Addendum No. 4

PROJECT: Vivie Nelson Care Center Renovation, Alexandria, MN

Subject: Addendum No. 4 for Bidding Documents for the
Vivie
Nelson Care Center Renovation
Alexandria, Minnesota

E6 LOWER LEVEL DEMOLITION PLAN - AREA A

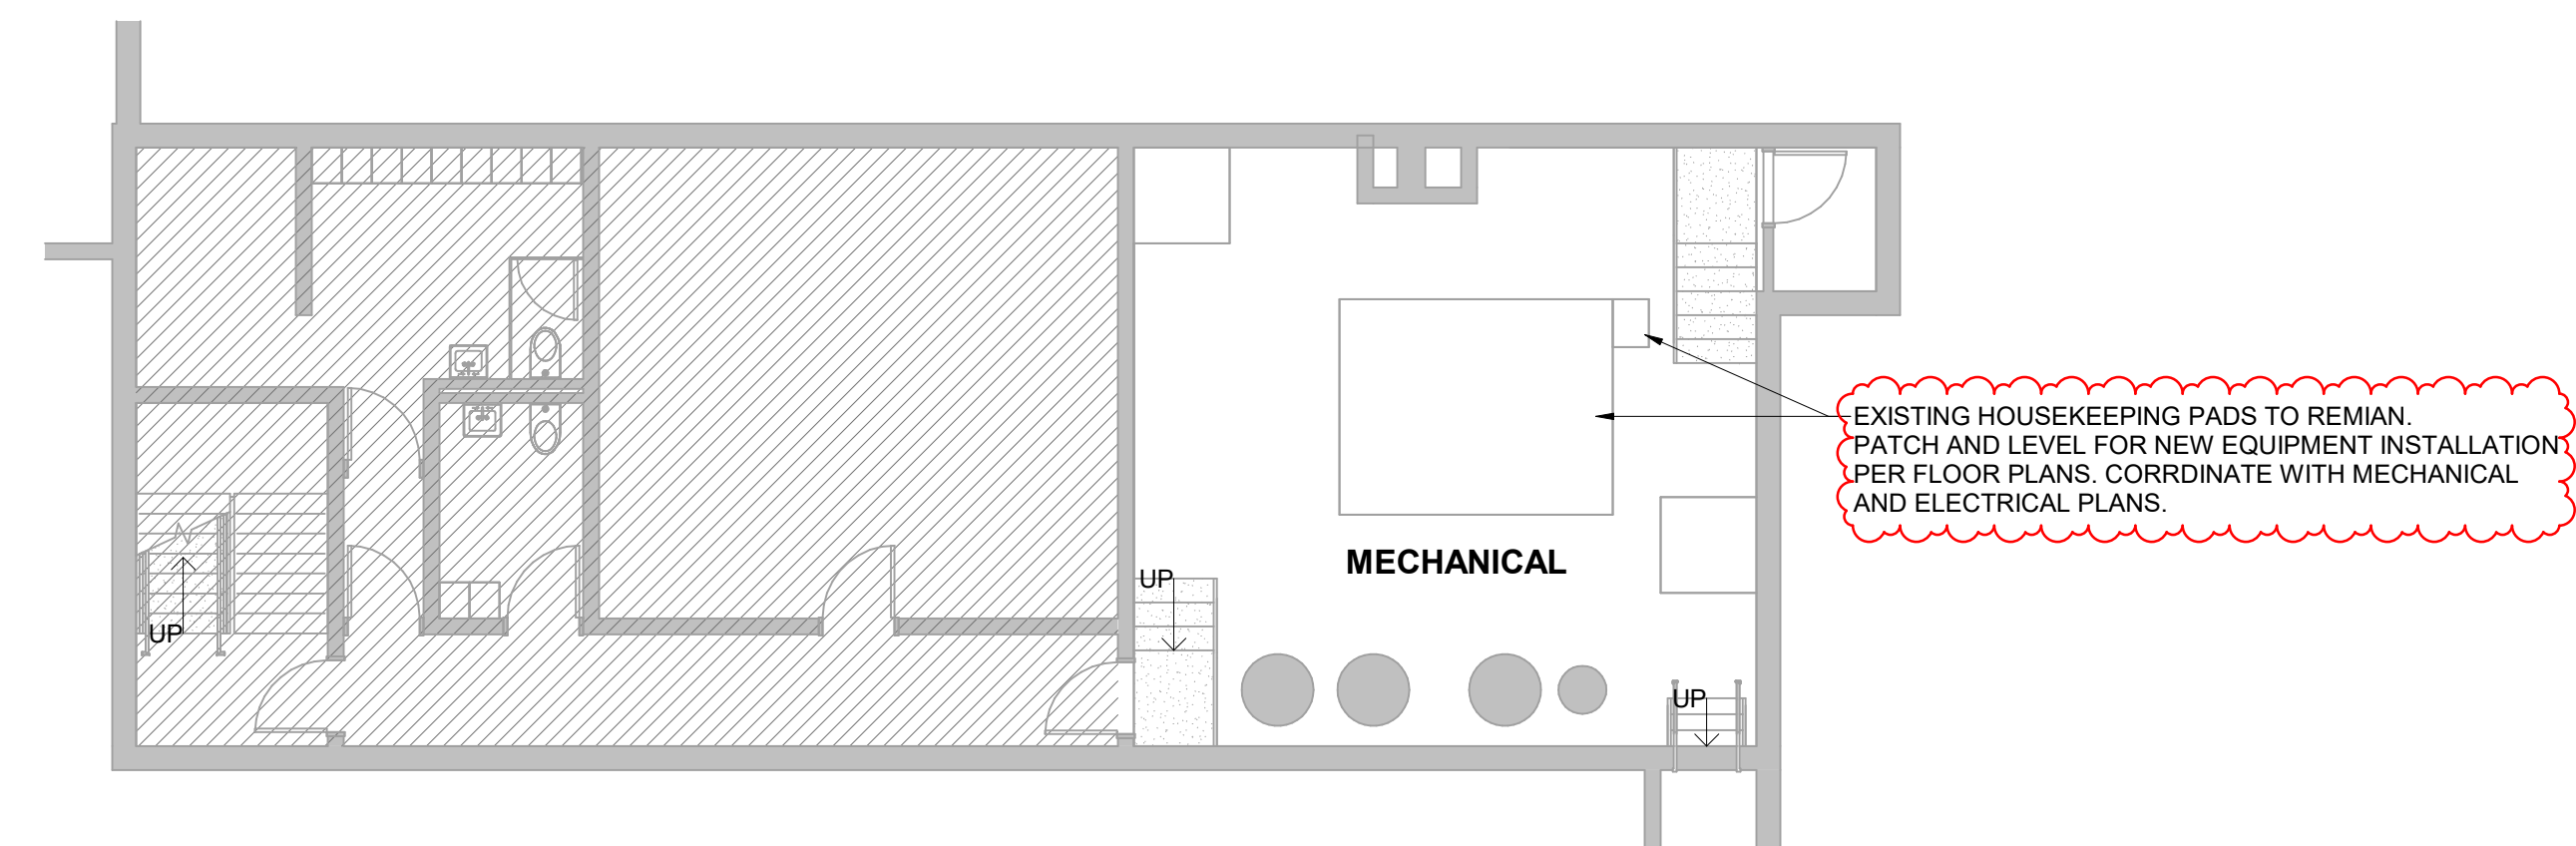
- 2. DRAWING A1.001a – FIRST FLOOR DEMOLITION PLAN - AREA A**
 - A. Reissued this addendum.
 - 1) Clarified extents of demolition to existing housekeeping pads as indicated on Detail E6/A1.001a.

F1 OVERALL ROOF PLAN

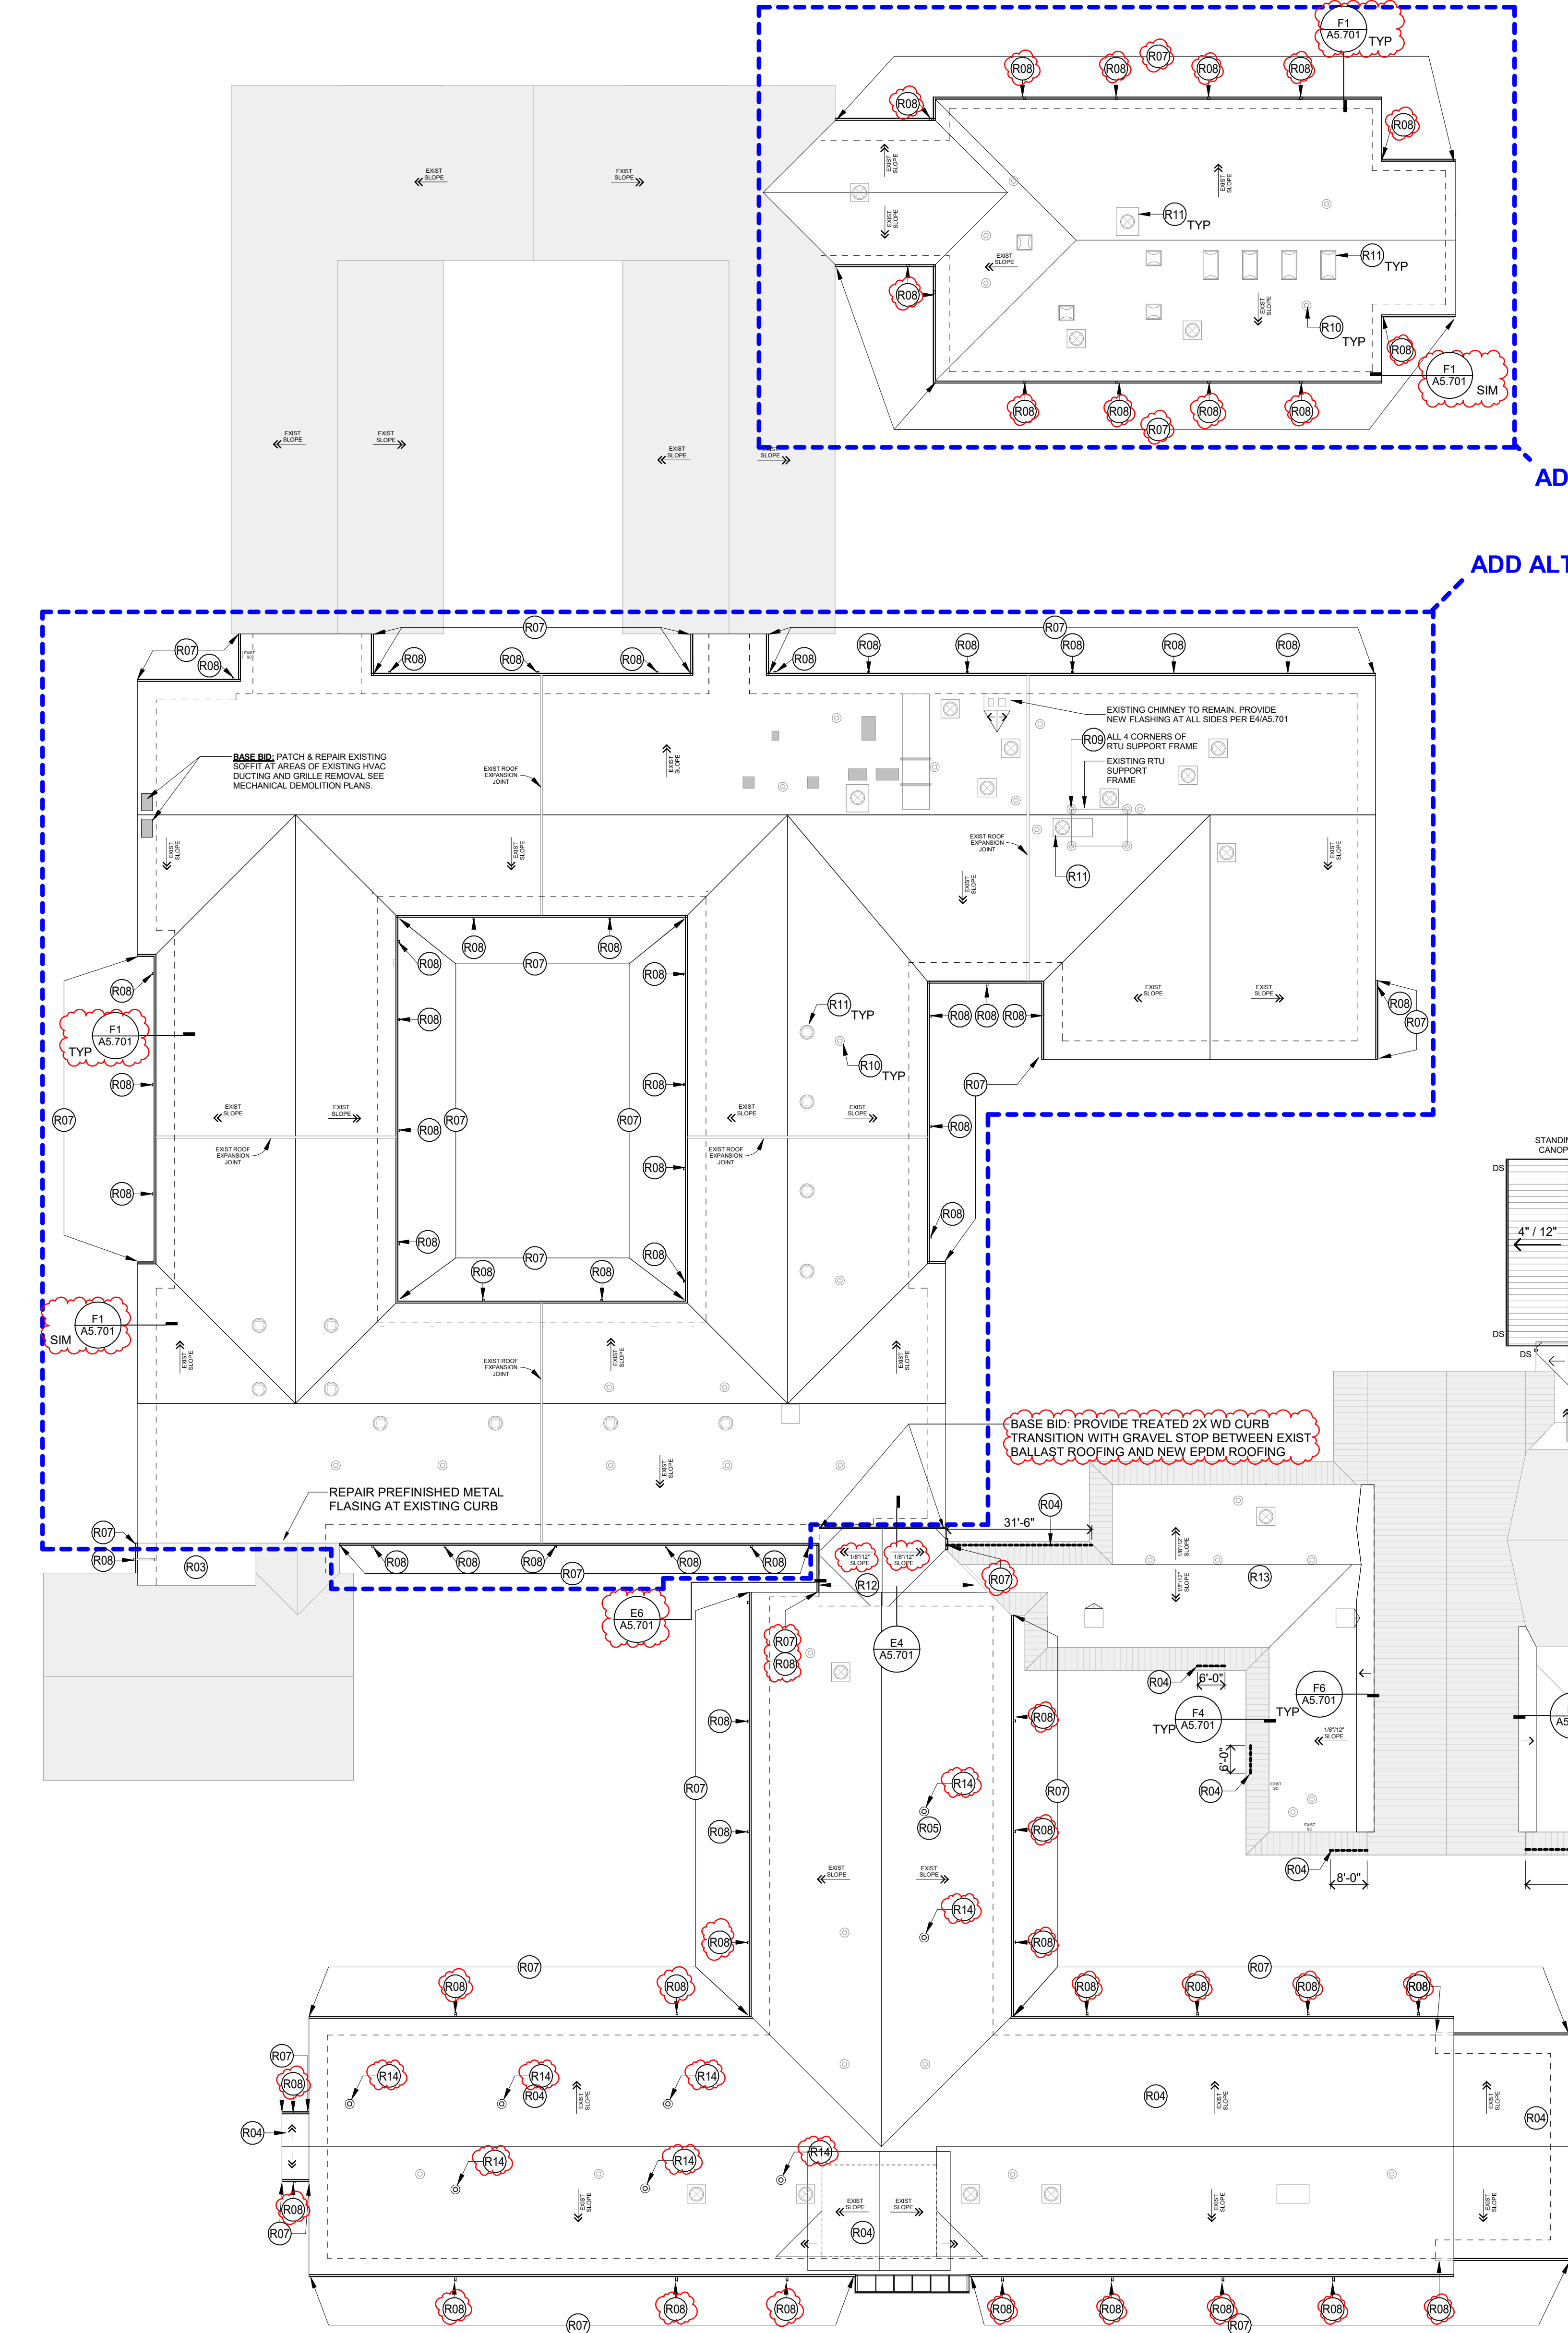
- 4. DRAWING A2.095 – ROOF PLAN**
 - A. Reissued this addendum.
 - 1) Clarified scope for gutters and downspouts as indicated on Detail F1/A2.095
 - 2) Added new vent stack/mechanical pipe penetrations as indicated on Detail F1/A2.095.

LOUVER TYPES

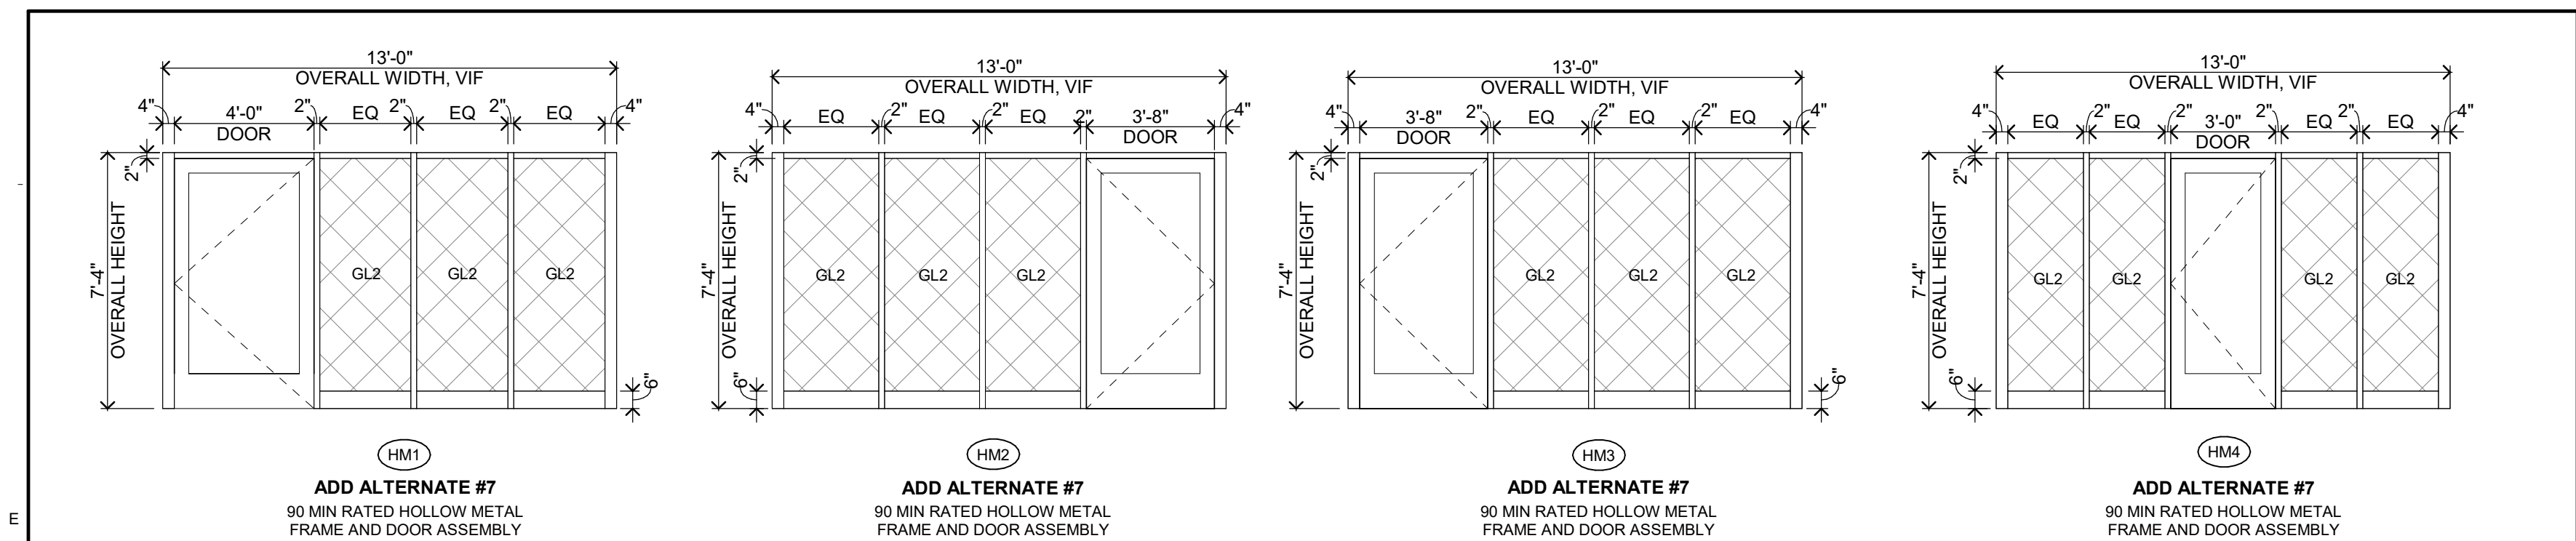
- A. Reissued this addendum.
 - 1) Revised opening details for louver type L3 as indicated.

D5 AREA B - TYPICAL SECTION @ THE MAPLES

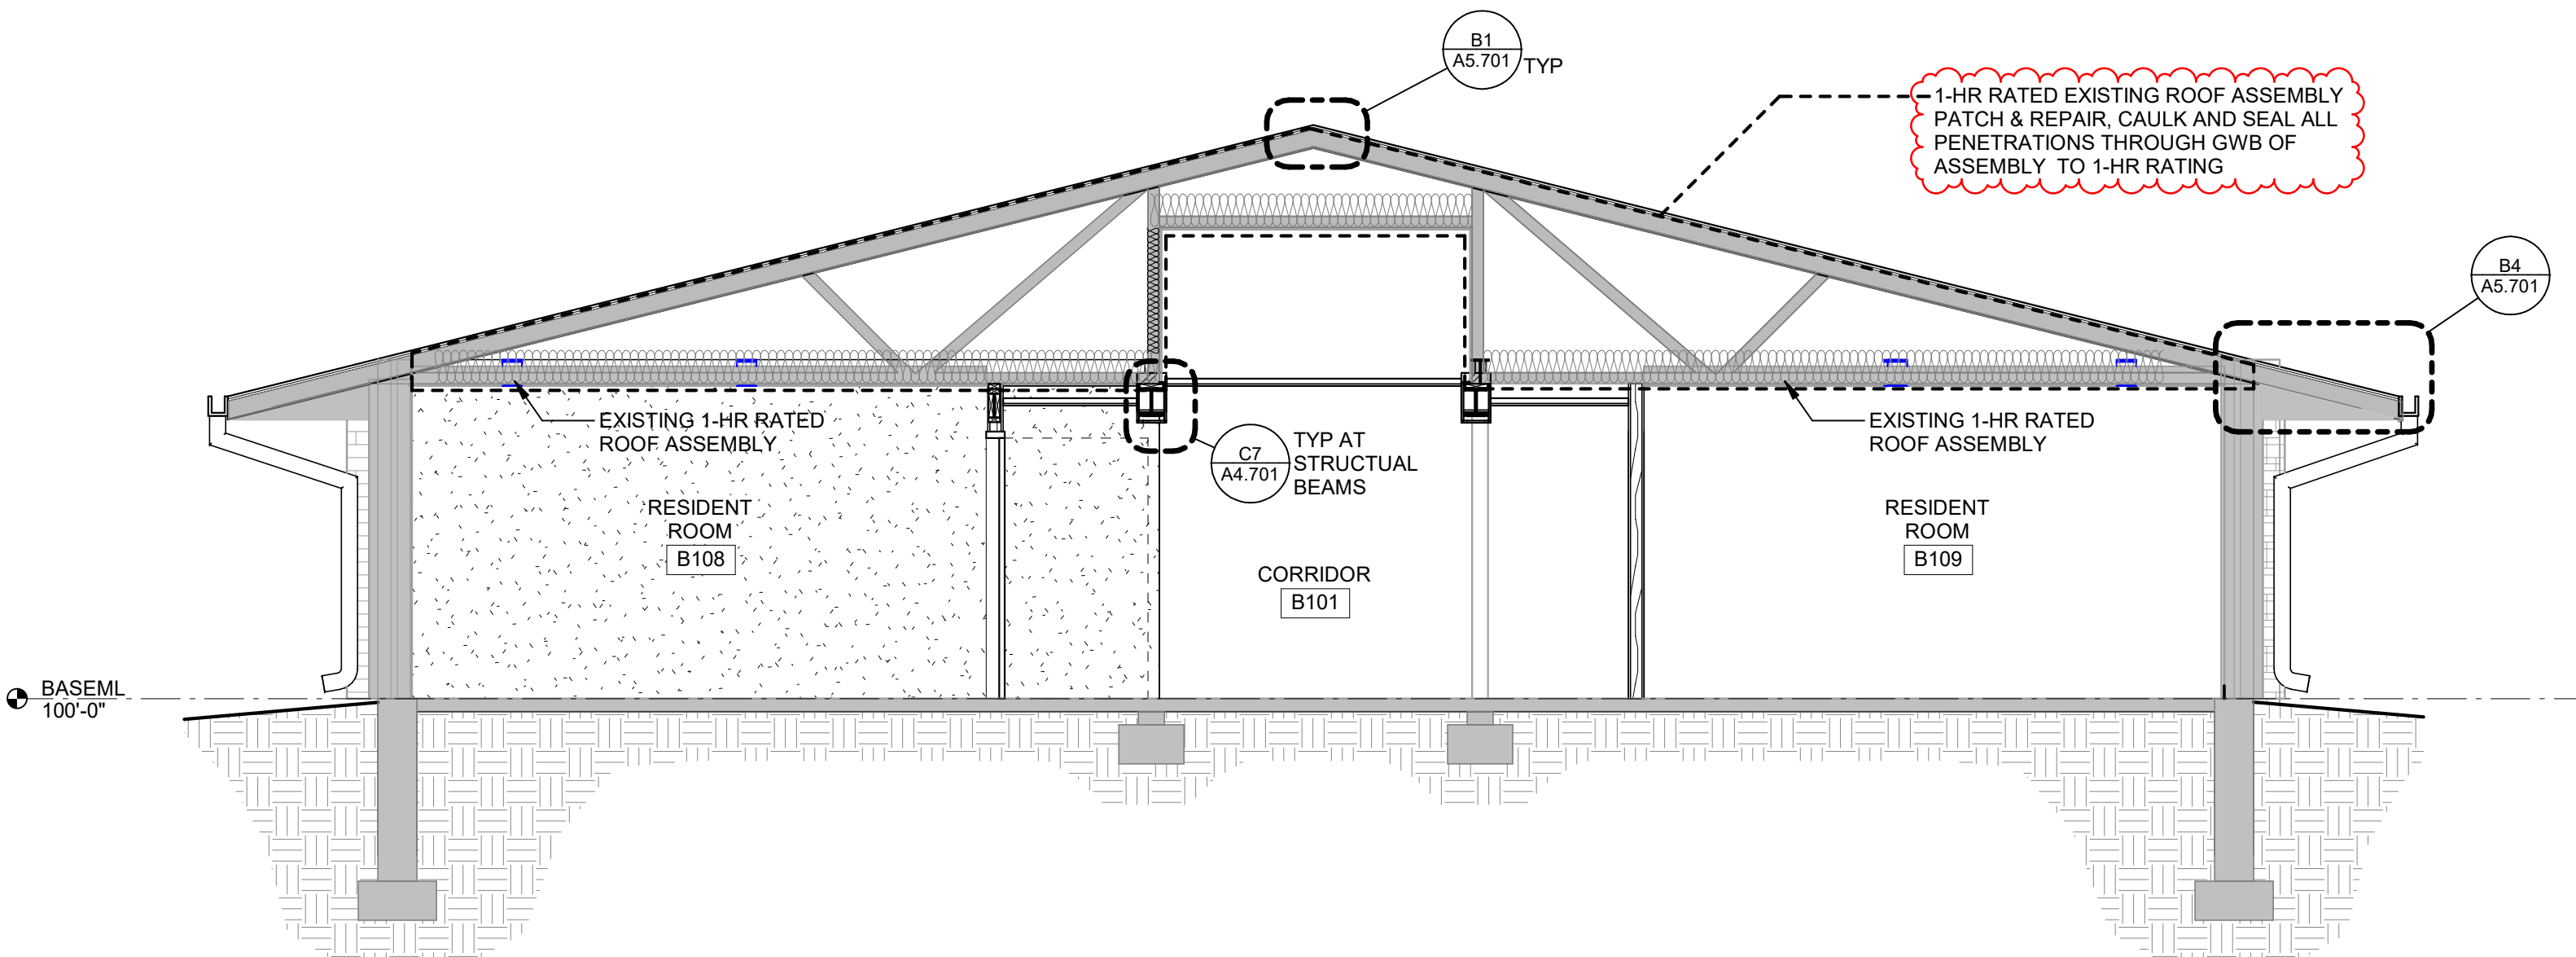
- 1) Clarified scope at existing Area B roof assembly as indicated on Detail D5/A5.204.
11. **DRAWING A5.601 - DETAILS - EXTERIOR OPENINGS**
 - A. Reissued this addendum.

57 LOUVER HEAD AT EXISTING MASONRY

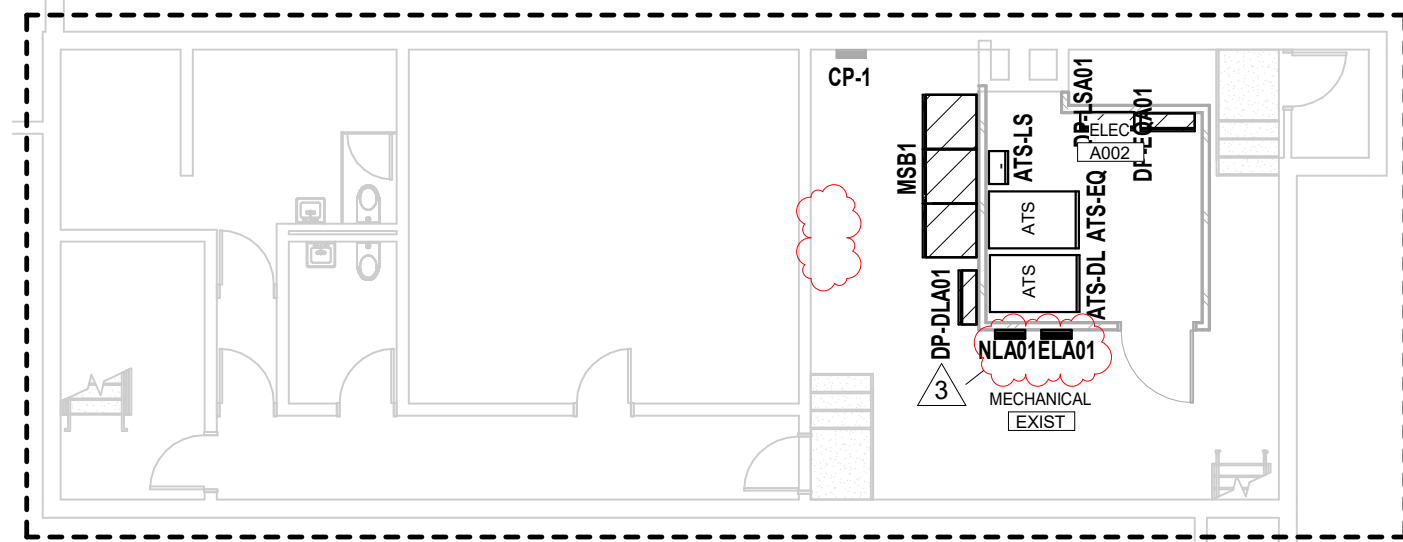
- 1) Added Detail F7/A5.601 for louver opening at existing masonry.
12. **DRAWING A5.701 - DETAILS - EXTERIOR ROOF**
 - A. Reissued this addendum.
 - 1) Added Detail E6/A5.701 for roof edge at existing concrete plank structure.
